# Addendum to the TMDL

Per EPA approval letter dated September 27, 2021, all Total Maximum Daily Loads (TMDL) in the document *TMDLs for Sulfate in the Upper Cornie Bayou Watershed, Arkansas* are withdrawn.

RE: Approved Withdrawal of the *TMDLs for Sulfate in the Upper Cornie Bayou Watershed, Arkansas*

**TMDLS FOR SULFATE IN THE UPPER  
CORNIE BAYOU WATERSHED,  
ARKANSAS**

**Figure 1: Map of Upper Cornie Bayou AUs with affected permits and DEQ monitoring station OUA0002 depicted.**

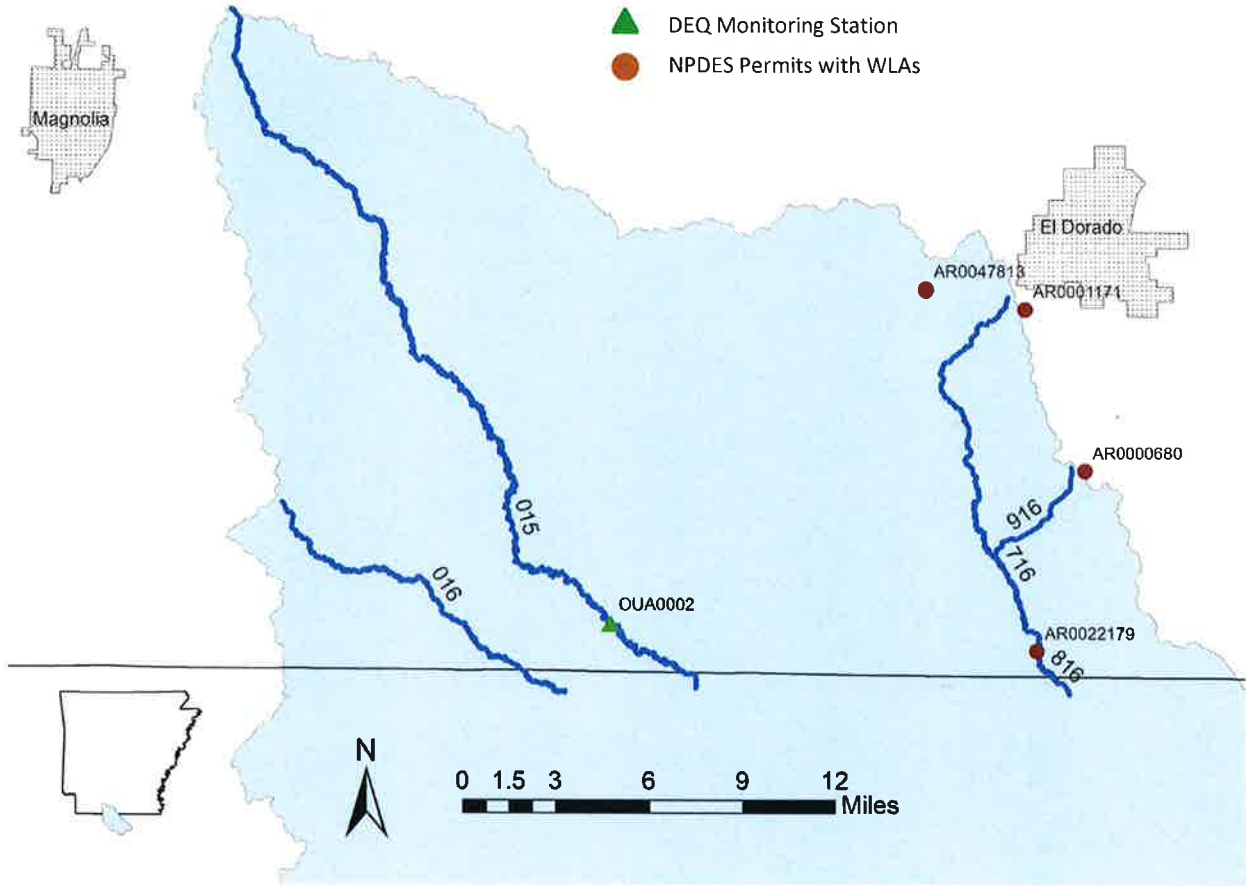
A 2011 TMDL report titled “TMDLs for Sulfate in the Upper Cornie Bayou Watershed, Arkansas” assigned sulfate TMDLs to five assessment units (AUs) and WLAs to four permits (Table 1, Table 2, and Figure 1 (attachment)).

**Figure 2: Sulfate data for OUA0002 located on AU AR\_08040206\_015 from 1990-2020. The solid line represents the site specific criterion of 30 mg/L for sulfates. The dashed line represents the 250 mg/L domestic water supply criterion. The large diamond represents the date the TMDL was approved.**

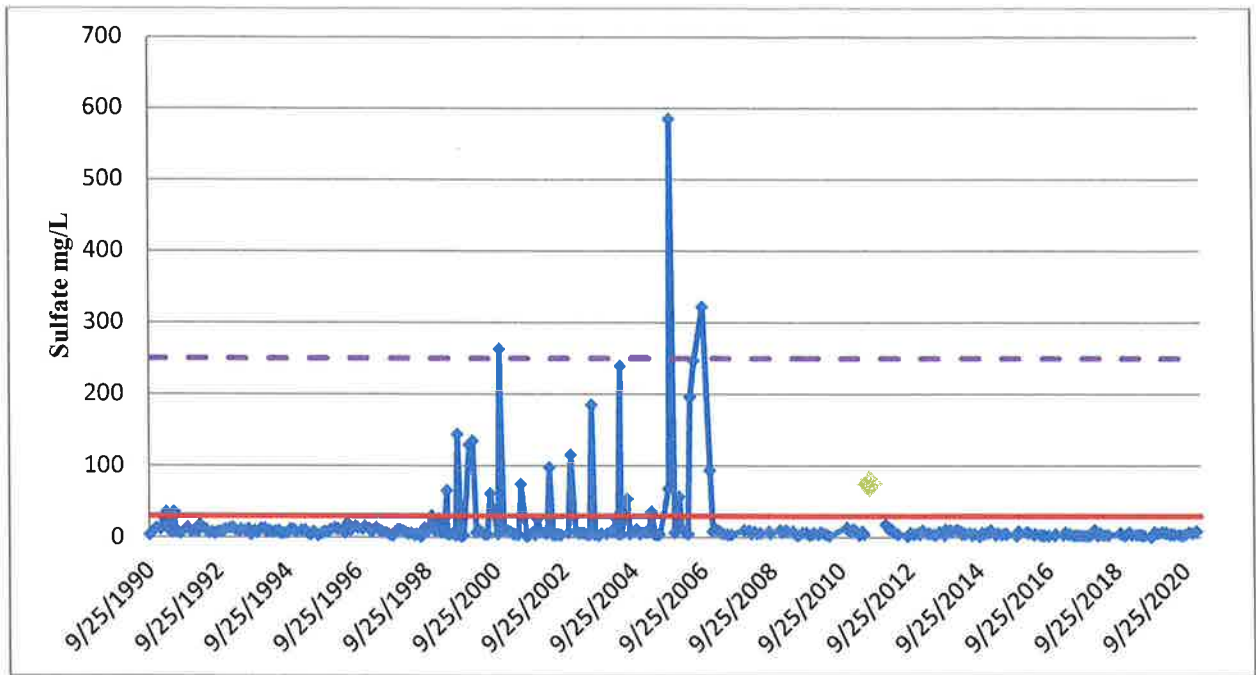
- The TMDLs did not bring the waterbody into compliance.
  - Instream data from the monitoring site used to list all TMDL AUs show that excursions from the site specific criterion (SSC) ceased before the TMDL was written (Figure 2). Excursions from SSC occurred between September 1998 and December 2006; the TMDL wasn't approved until 2011. No exceedances of the SSC of 30 mg/L have occurred since January 2007.
- The TMDLs have never been implemented.
  - Only one permit with a WLA has been renewed since the TMDL was approved, but that permit is on a schedule of compliance and has not begun any actions to comply with the TMDL.
- Unjustified TMDLs and WLAs place unnecessary burden on point source dischargers.
